Re: Form 731 Confirmation Number: EA102411 with FCC ID: AZ489FT3803.

Motorola Inc., 8000 West Sunrise Boulevard, Fort Lauderdale, Florida 33322, herein submits its response to the 14th November 2001 request for information in Correspondence Number 21236.

XV2600; 11/21/01

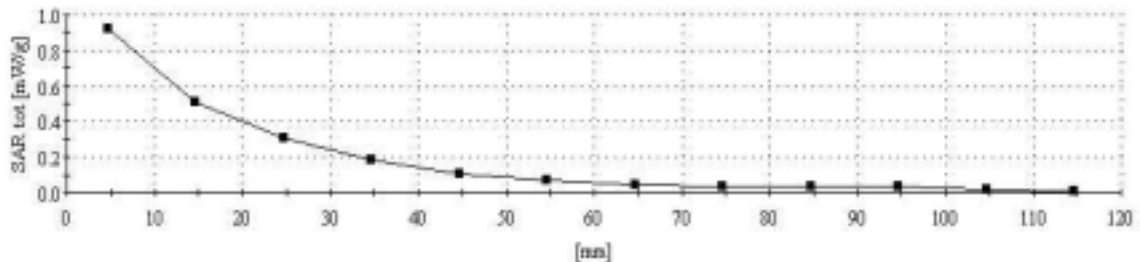
Q6) Please submit a graph of SAR reading vs depth (z-axis scan) for the peak SAR condition in the EUT configuration having the maximum reported volume-averaged SAR. Graph for this z-axis scan must be generated such that the probe comes out of liquid, or the SAR goes to zero, whichever comes first. Reading points should be spaced at 1 cm.

R6) Please see the graph of SAR reading vs depth (z-axis scan) for the peak SAR condition in the EUT configuration having the maximum reported volume-averaged SAR below.
